Control House Planning Application – Havant Thicket Reservoir

Application reference: [Planning Application: APP/25/00988](#)

Discharge of Conditions reference: – [Planning Application: APP/25/00989](#)

Figure 6.4: Indicative Layout

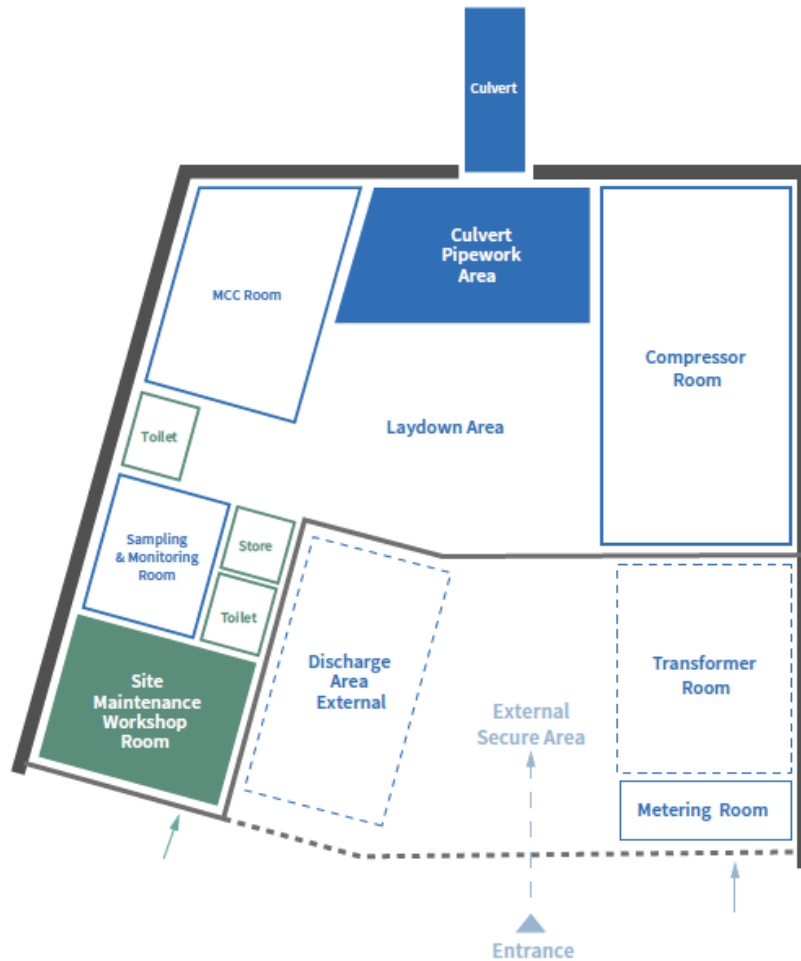
The facility was clearly shown on the indicative layout on page 38, copied below for ease of reference, yet this facility is NOT provided in the new design.

The new Control House layout does **NOT** include a Site Maintenance Workshop Room and this **represents a material change** to the outline design considered and approved by the LPA in 2020/21. This is despite the building footprint having increased from 430m² to 567m².

The applicant makes reference to consideration of providing the facility in the reservoir Visitor Centre area, but there is no clear commitment to where it will be provided, or even that it will definitely be provided. It is not shown on the drawings for the Visitor Centre, nor hub building for the NW area which were recently shared with stakeholders.

Given the material change to omit the Site Maintenance Workshop Room from the Control House design it is important that Portsmouth Water make it clear in writing to the LPA that this essential facility for grounds maintenance and external volunteers will be provided on site with ample space, and the location agreed with the LPA.

The LPA should NOT approve the Control House design until it is clear that a suitable alternative location for a Site Maintenance Workshop Room with adequate space and facilities will be provided on site.

If the detail cannot be agreed in writing before consent for the Control House is required, then **the LPA should include a planning condition to ensure that a suitable facility will be provided**, with the minimum size and servicing of the facility agreed with Forestry England and Hampshire County Council (SCP) management to be included in the condition wording. The location must have good vehicle access and ideally where staff and volunteers will have access to a toilet/ wash basin, a sink and power supply.
